APPENDIX A

A2. Correspondence

- i. 1st Submission Comments***
- ii. Meeting Minutes***
- iii. Hydrologic Modelling***
- iv. Buffers and Allowances***

**DRAFT PLAN OF SUBDIVISION
ORLANDO CORPORATION**

Project No.	99067A
Date	MARCH 2000
Scale	1:20,000
Figure No.	9

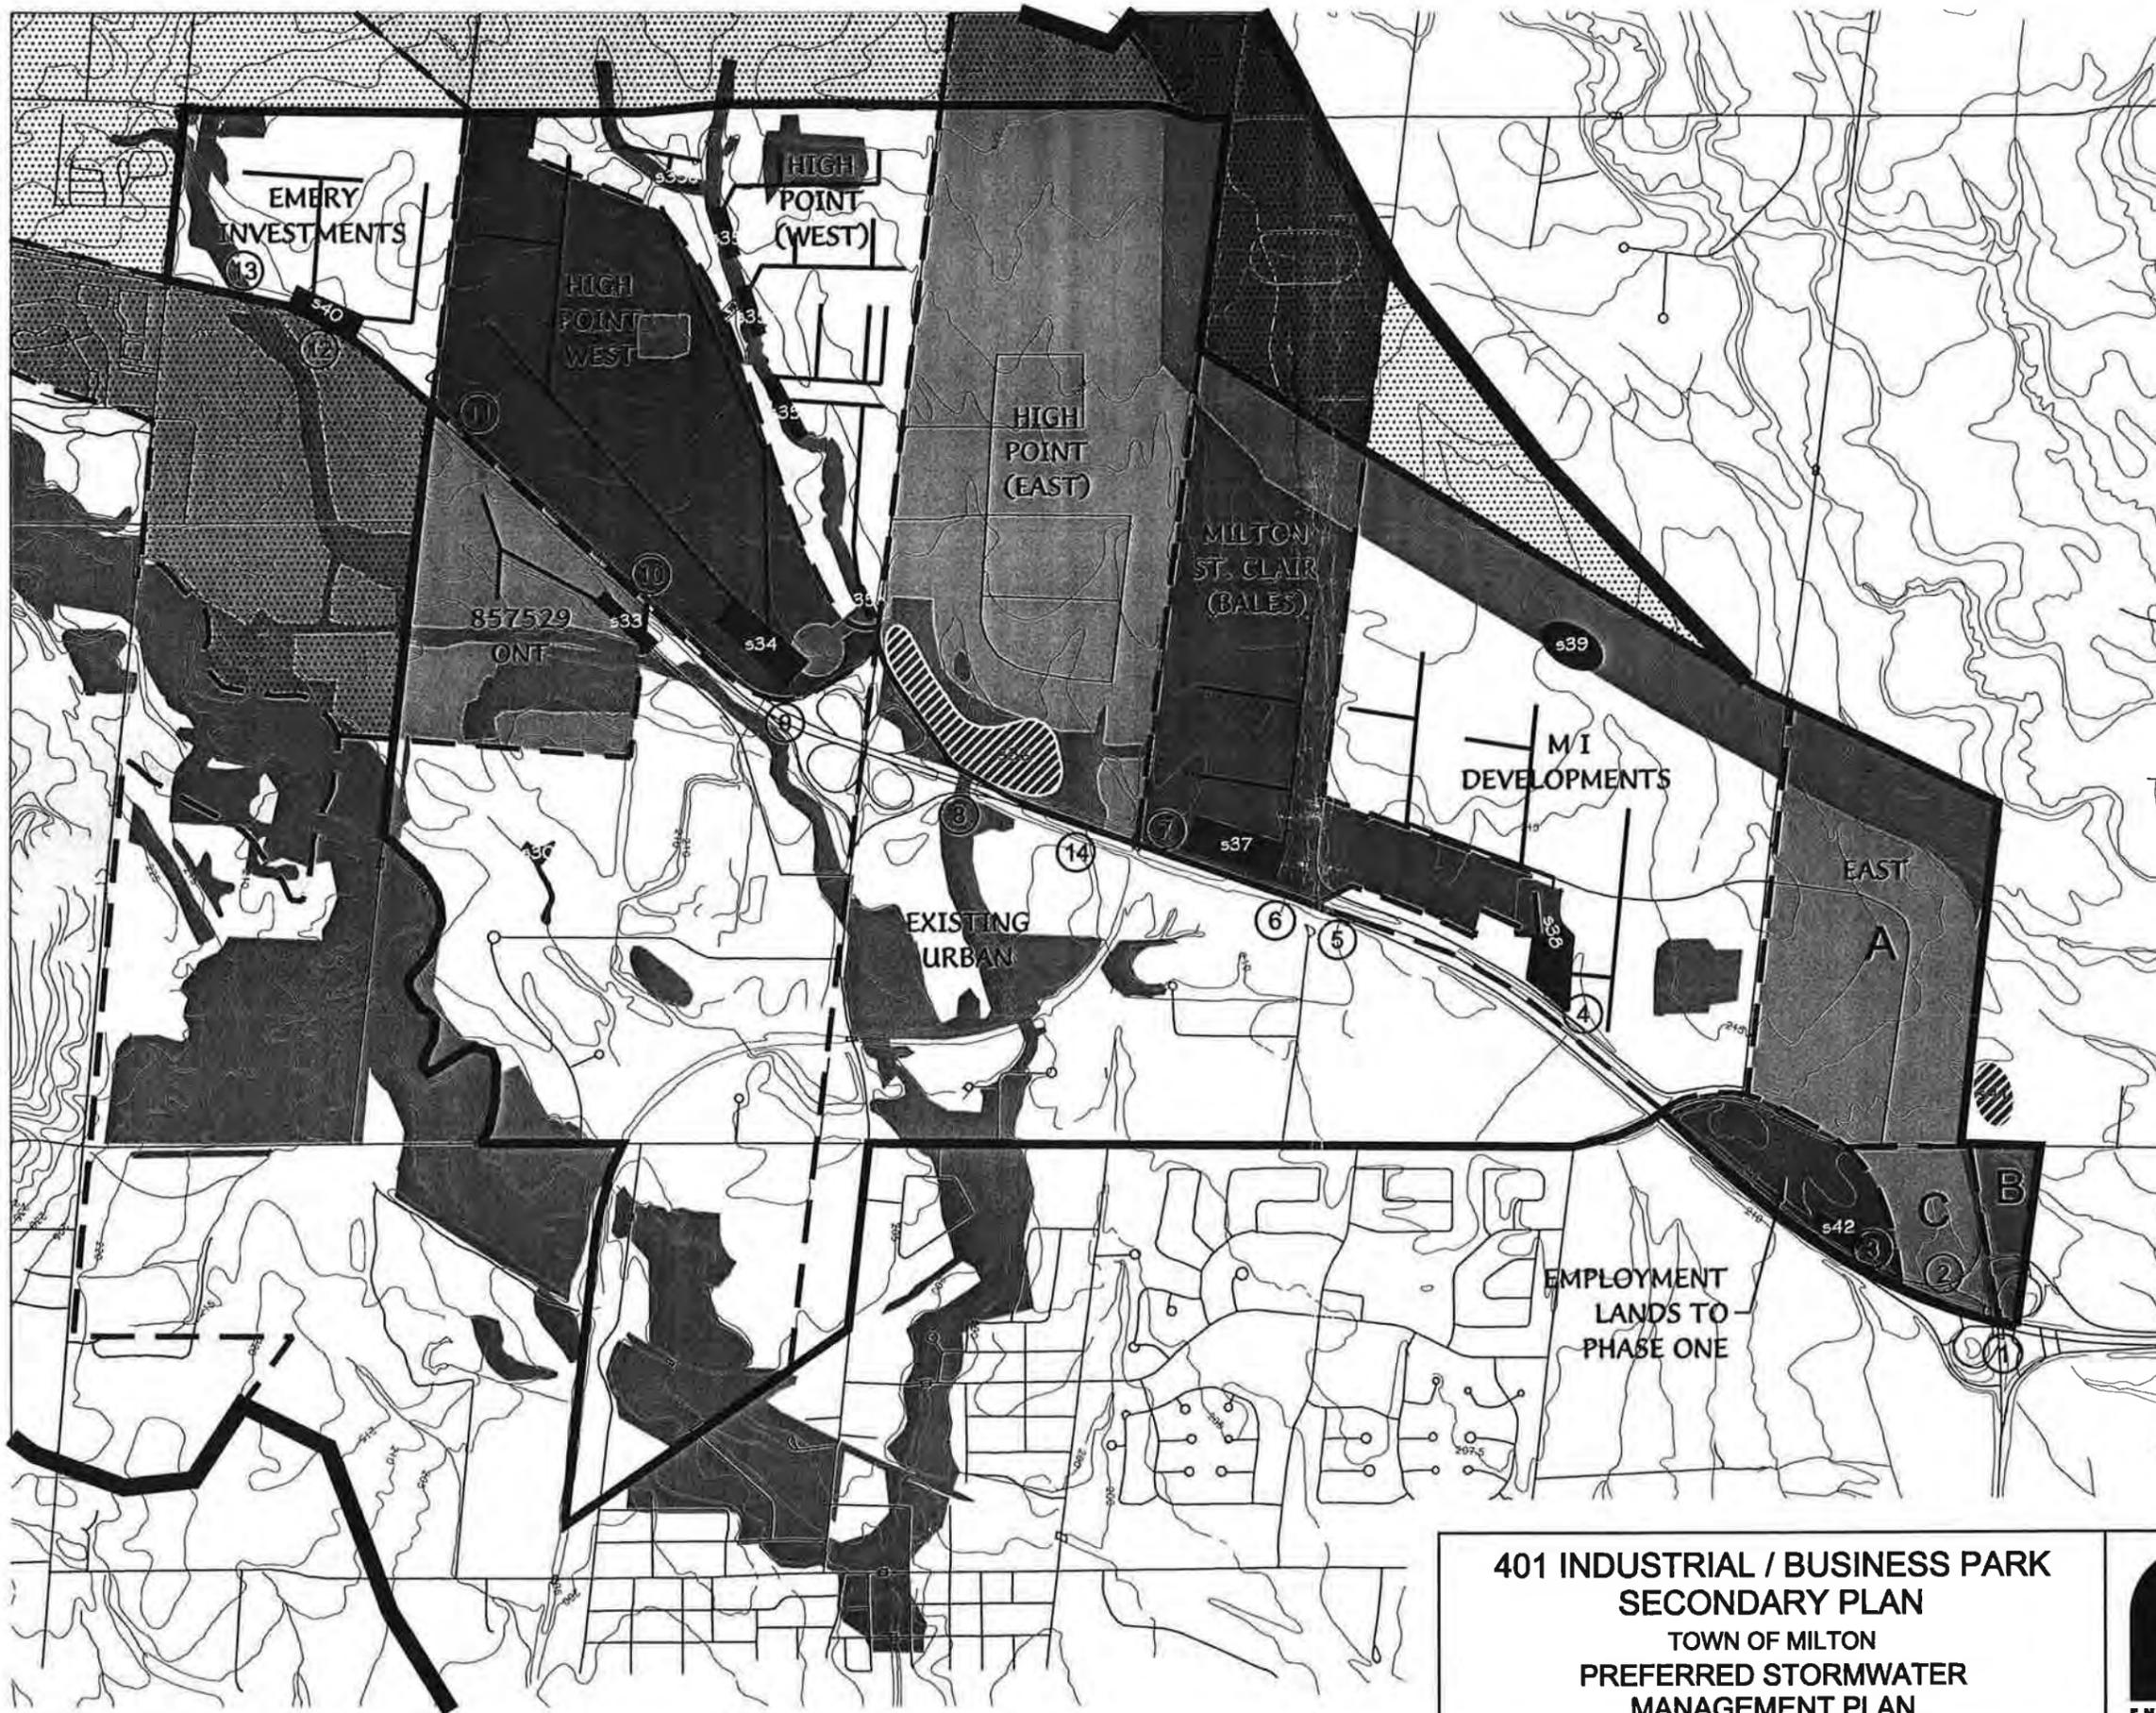
Figure 9 - The existing stormwater pond appears to be shown much larger than its current size is and it is identified as a potential retrofit opportunity. Any changes to this stormwater pond must have regard for the fact that an 11 metre easement was preserved in the area to allow wastewater servicing of the area west of Regional Road 25.

Figure 9, there is an existing stormwater quantity facility at the corner of Industrial Drive and Steeles Avenue which is not identified on the plan. The function of this facility should be confirmed with the Town. As noted in the text of the report, there may be potential for retrofitting the channels within the existing urban area of Milton. These opportunities should also be highlighted on Figure 9.

SCALE: N.T.S	PROJECT No.	17197
DATE: FEBRUARY 2022		
DESIGNED BY: T.D/E.T	DRAWN BY: S.B.	FIGURE No.
CHECKED BY: S.H.	CHECKED BY: E.T.	5-1A

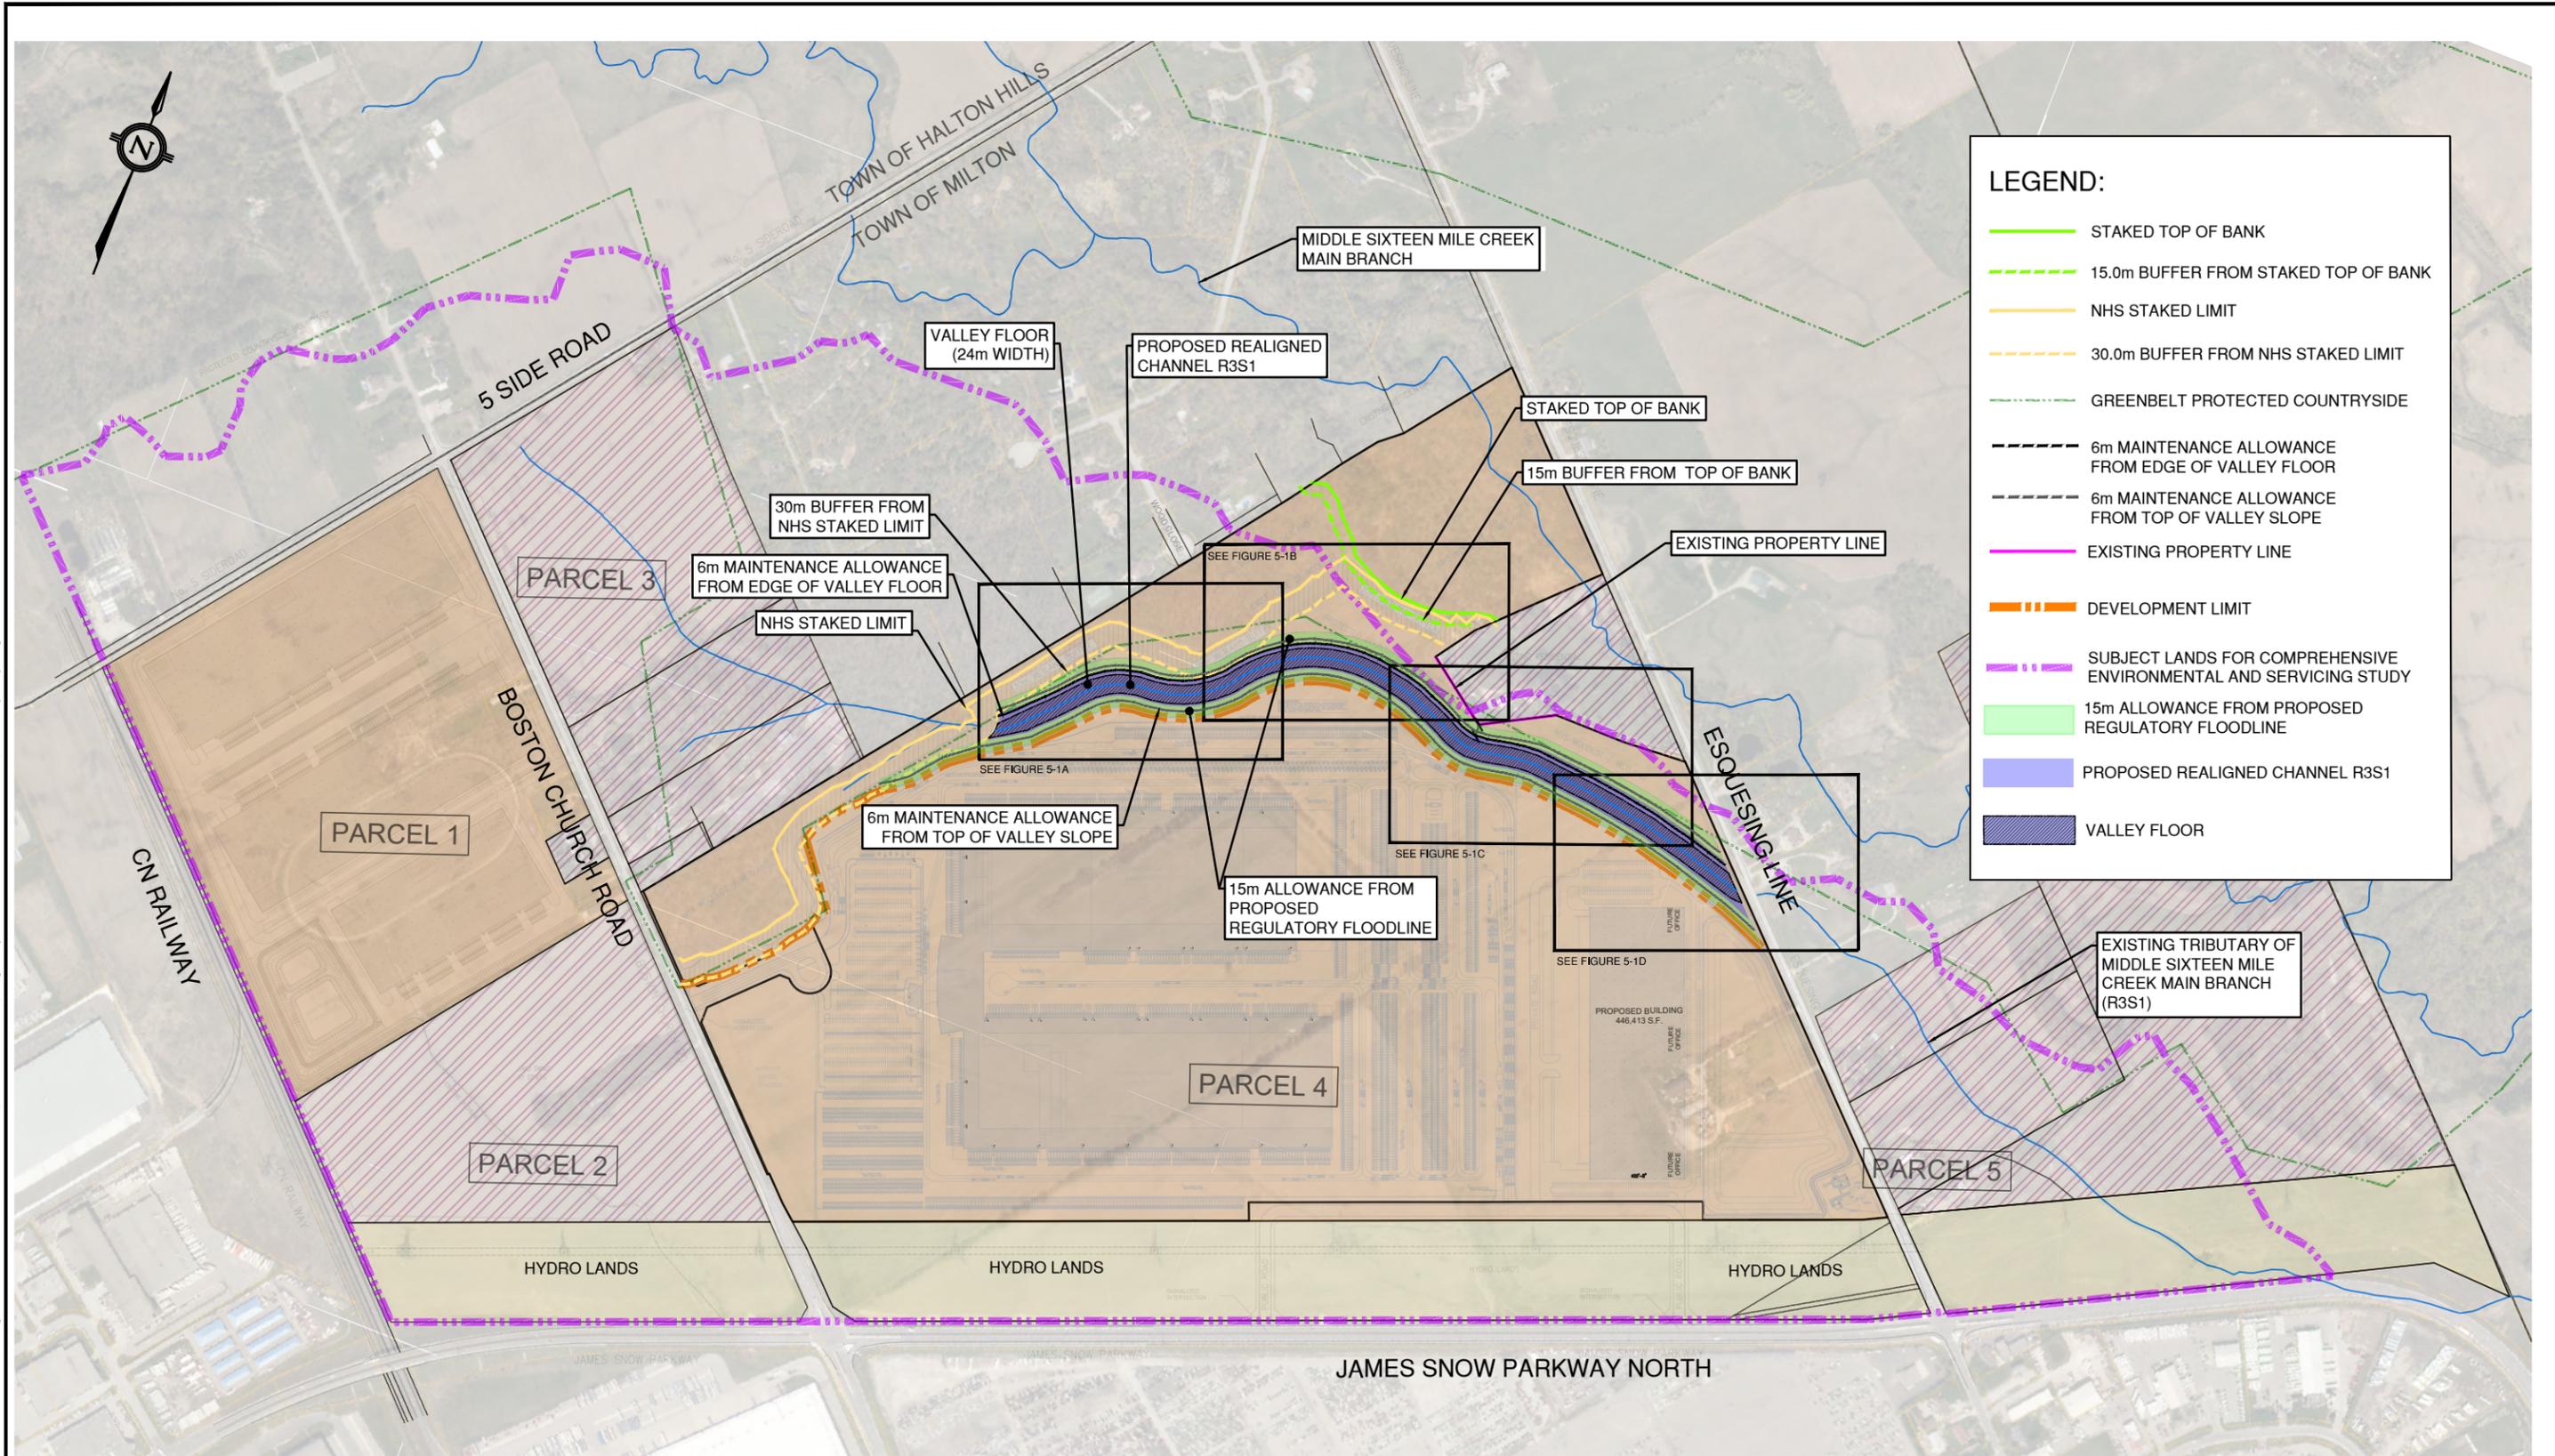
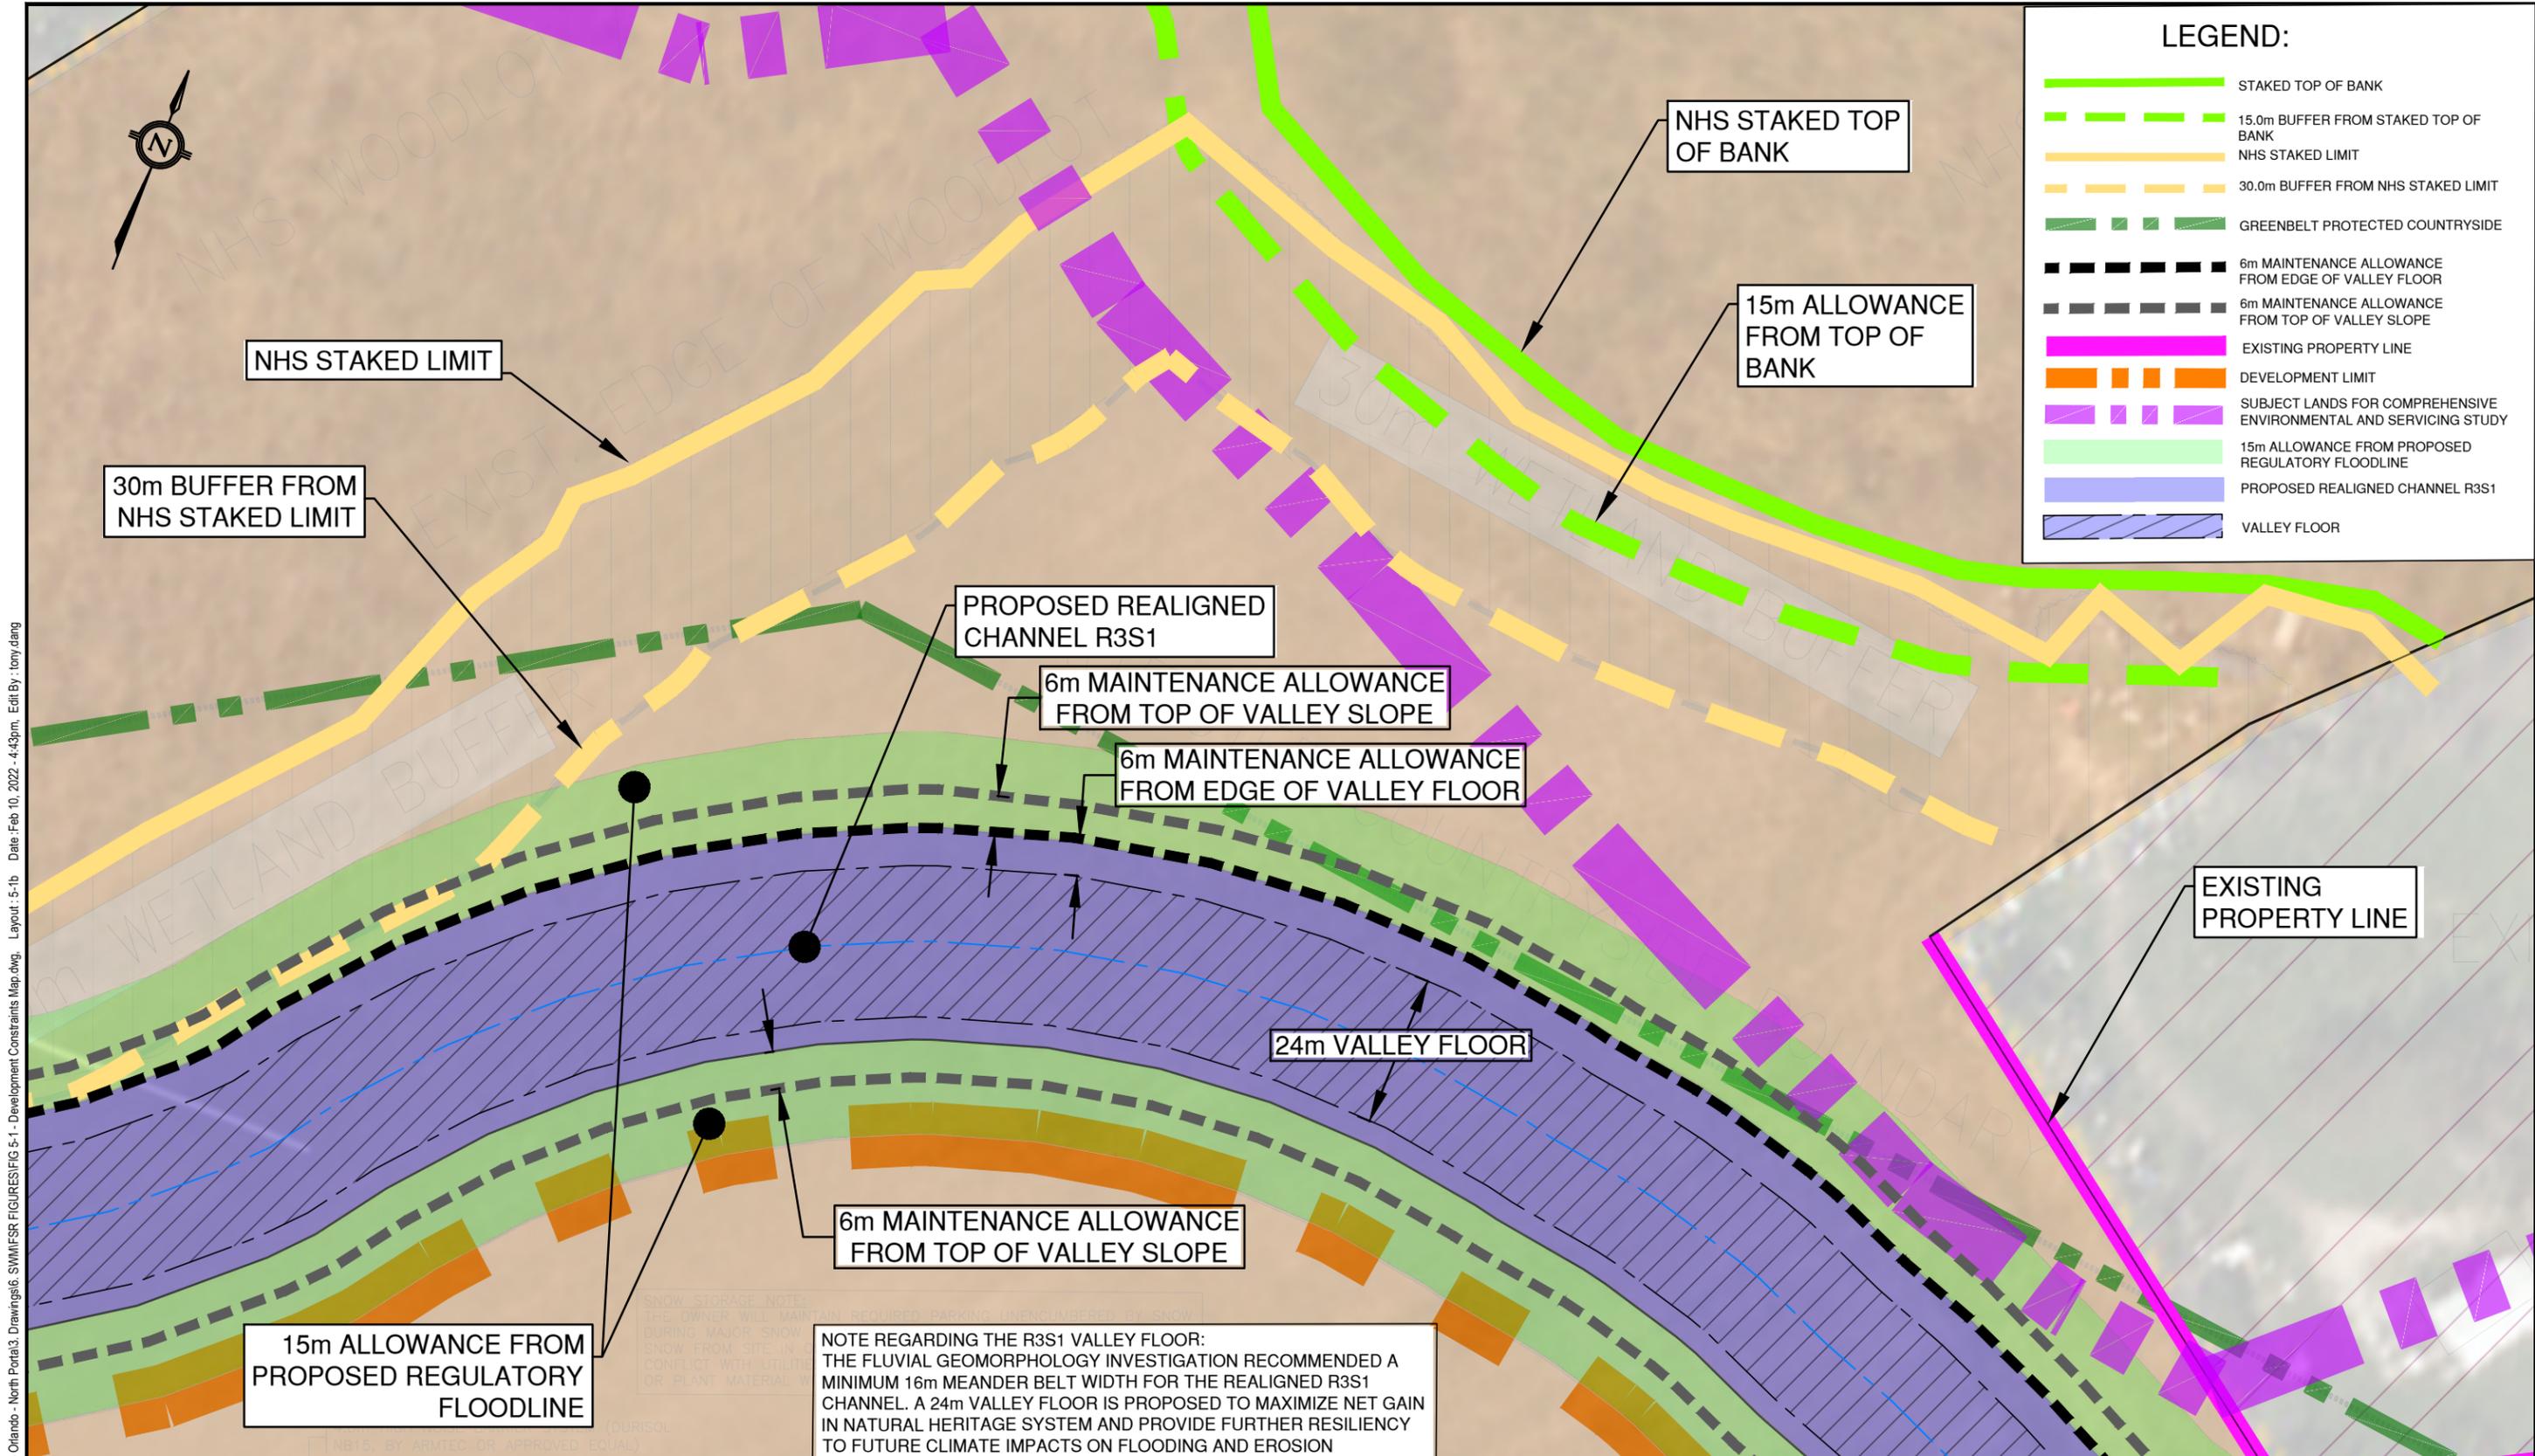
- xiii) Section 6.1.10 – There is discussion on both a 15 m regulatory setback from the proposed floodline, and from the top of bank (on the development side of the channel). It is unclear in Figure 5-1 that there is a setback from the top of the design valley, rather it states from the floodline. If the design corridor conveys the Regional Storm flood up to the top of bank, then the limit would be the same. The text is somewhat unclear when reviewed in the context of Figure 5-1.
